1317 N TEJON ST NORTH-SIDE WINDOW AND EAST DOOR PROJECT

Historic Preservation Board – October 7, 2024

Staff Report by City Planner: Johnny Malpica

2
A-2 EXISTING NORTH WINDOW

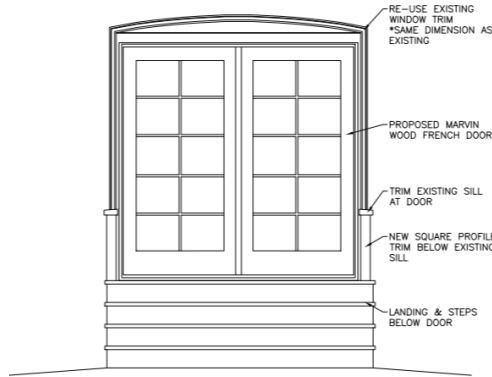
The project proposes the conversion of an existing glass bay window along the northern side of the house with a traditional style wood awning window that matches the architectural vernacular of the primary structure. Additionally, the proposal includes the replacement of an eastern (rear) double window with a wooden double door of a traditional style that includes a new staircase with four risers and a railing. Both of the changes included in this Report of Acceptability demonstrate attention to the structure's architectural vernacular and historical significance. Additionally, it should be noted that the existing bay window on the side of the home is averse to the building's architectural style, both from a stylistic and material perspective. The proposed replacement window is both aesthetically and materialistically consistent with the structure's architectural fenestration. As such, the side window replacement represents an improvement to the building's historic architectural style. The rear door with staircase is both minimally visible from public view and matches the building's architectural form and fenestration and is expected to have a minimal impact to the historic value of the home and property it is seated on.

This project maintains the visual integrity of the Old North End Historic District through the use of traditionally styled wooded windows and doors with divided light grills. Furthermore, the steps that serve the rear doors integrate features including stained wood like decking, iron guardrails, and a lattice skirt that are consistent with the overlay zone.

As described above, the proposed window and door replacement includes carefully selected materials that pay attention to the building's historic architecture. As such, their size, composition, quality, and appearance are consistent with those used historically.

9 PROPOSED EAST DOOR STEPS
A-2 SCALE: 1/2"=1'

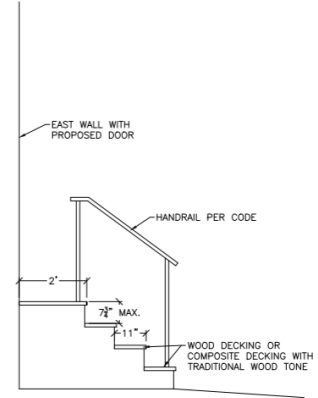
The placement of the patio door and steps are done so to as to be oriented along the southern side of the primary structure, maintaining a setback that is consistent with that of the existing home, where porch features are aligned along the southern side of the home.
